DESIGN <i>PH</i>	DRAWN BY <i>PH</i>	<b>DART AEROSPACE LTD</b> HAWKESBURY, ONTARIO, CANADA	
CHECKED <i>[Signature]</i>	APPROVED <i>[Signature]</i>	DRAWING NO. DSI 9372	REV. A SHEET 1 OF 2
DATE 07.03.19		TITLE STAINLESS STEEL WEARSHOE KITS	SCALE NTS
A	07.03.19	NEW ISSUE

## **DART SERVICE INSTRUCTION**

**TO AMEND INSTALLATION INSTRUCTIONS D205-634 REV. D OR EARLIER AND  
INSTALLATION INSTRUCTIONS D204-635 REV. D OR EARLIER**

**FIGURE 1: DSI9372-011/-013 WEARSHOE KIT INSTALLATION**  
(D205-634-011 SKIDTUBE SHOWN, D204-635-011 SIMILIAR)

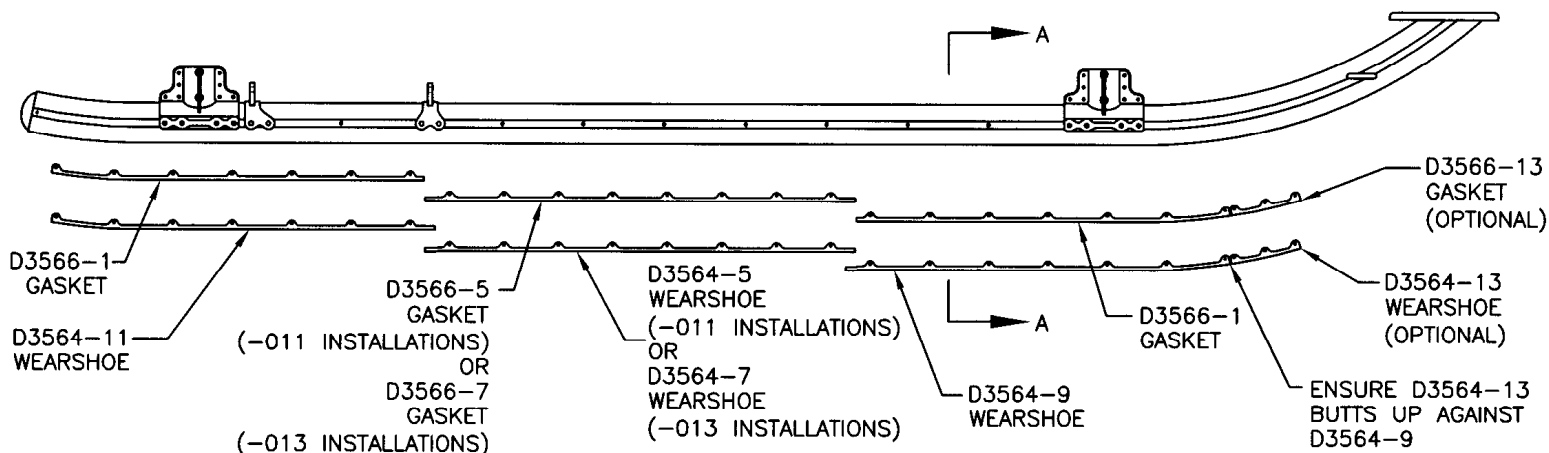
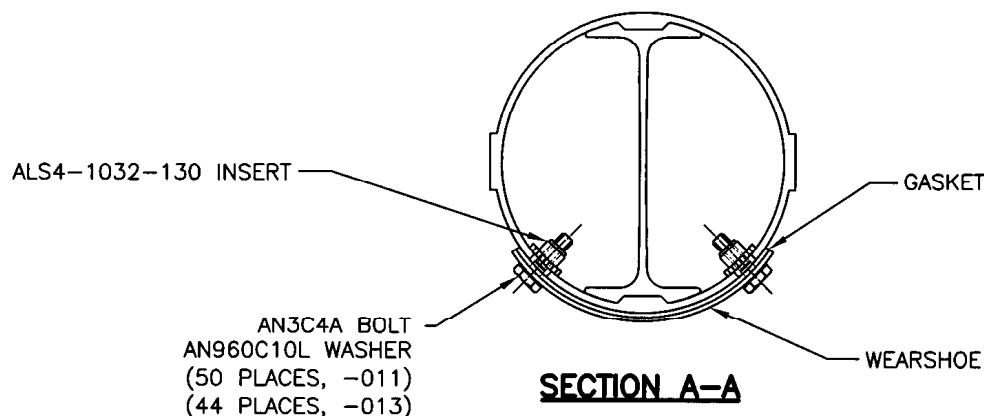
For customers with D205-634-011 skidtubes at CHG 004 or earlier and D205-634-015 skidtubes at CHG 003 or earlier who would like to upgrade to stainless steel wearshoes, the DSI 9372-011 wearshoe kit can be obtained from Dart

For customers with D204-635-011 skidtubes at CHG 004 or earlier who would like to upgrade to stainless steel wearshoes, the DSI 9372-013 wearshoe kit can be obtained from Dart

- 4) **Installation of D3564-13 Wearshoe and D3566-13 Gasket (optional)**  
Temporarily install the D3564-9 wearshoe complete with D3566-1 gasket at the fwd end of the skidtube as shown in Figure 1. Temporarily clamp the D3564-13 wearshoe and D3566-13 gasket ensuring that the wearshoe butts up against the D3564-9 wearshoe. Using the D3564-13 wearshoe as a template, drill  $\varnothing 0.125$  holes in the center of the wearshoe oboonds (6 places). Remove wearshoes and open the  $\varnothing 0.125$  holes to  $\varnothing 0.297$ . Deburr. Touch up holes with chemical film material (Alodine 1200/1201) per MIL-C-5541 and one coat of MIL-P-85582 or MIL-P-23377 primer. Install ALS4-1032-130 inserts.

- 5) Install D3564-5/-7/-9/-11/-13 wearshoes complete with D3566-1/-5/-7/-13 gaskets using AN3C bolts beginning from the aft end of the skidtube and install towards the fwd end of the skidtube as shown in Figure 1. Seal all bolts with Sikaflex-241/-291 or Proseal 890 or MIL-S-8802 Class 'B2' sealant before installing. Torque bolts to 15-25 in-lbs (1.7-2.8 N-m).
